UI Bulletin #162

Subject: Rear Chassis Electrical Harness attachments replacement upfit interface

Models Affected: Chevrolet Silverado, GMC Sierra 3100 Series HD Cab Chassis models only

Figure 1

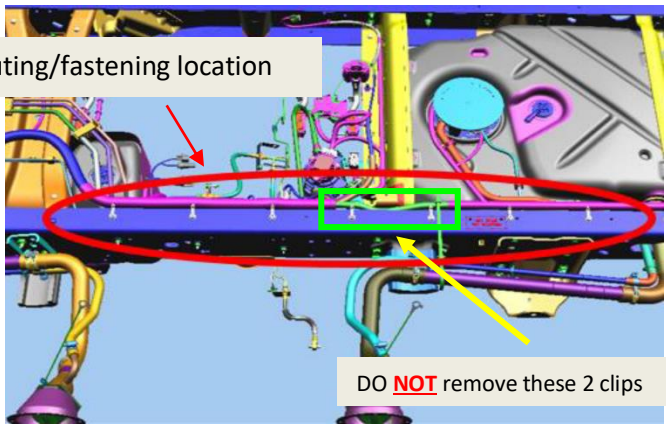
Some Chevrolet Silverado, GMC Sierra 3600 Series Cab Chassis upfits may require alternative rear chassis harness attachments. Wiring Harness `Service Access' could be compromised when mounting an upfit body. Upfit Body mounting provisions could lock in the OEM harness/attachments.

1) Remove with wiring snips, **6** of the 8 factory black plastic harness clips in areas shown (see Fig. 1)
IMPORTANT: Do **NOT** remove the 2 factory plastic attachment clips **(green area)** located by the rear fuel tank lines.

Upfit body mounting practices should allow for service of chassis wiring harness/attachments. For upfits that utilize semi-continuous `top of frame rail' contact, it is recommended that the rear electrical harness attachments be replaced with alternative `service accessible' components. The following will provide instructions for replacement of the OEM rear harness attachments if it is deemed necessary refer to figure 1.

Figure 2

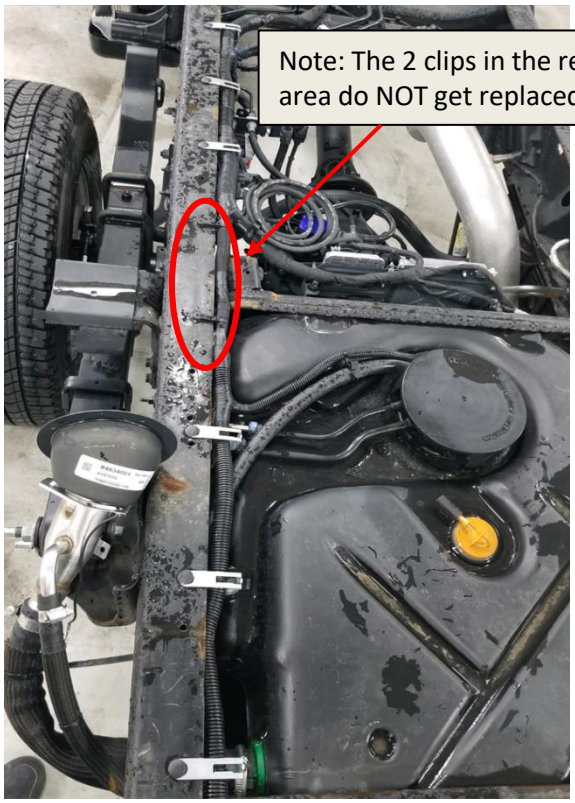
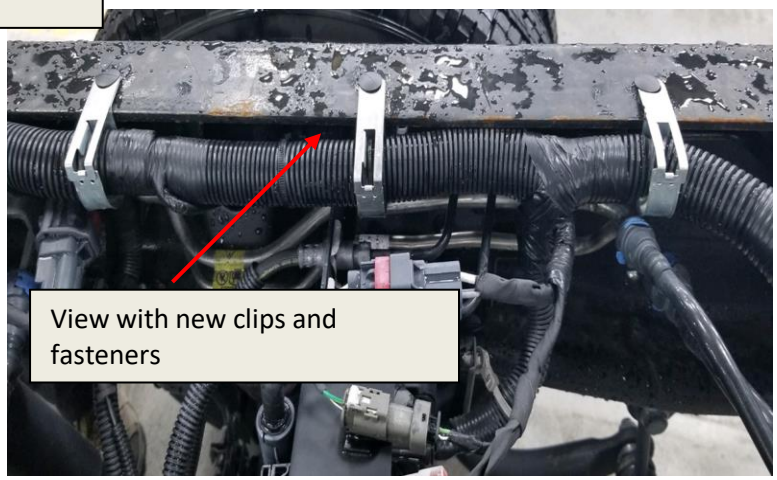
2) Replace removed attachments with (6) new metal hoop clips & low-profile plastic push-pins as shown in Figures 2 & 3. Use recommended GM Service or OEM supplier parts listed below.

Part Name	Supplier	Part Number	Required Qty.
CC Rear Harness Attachment Kit	GM Service	35447259	1 Kit
Metal Harness Hoop Clip	Aptiv	15495911	6
Fasteners	ITW[1]	39-0630-10	6
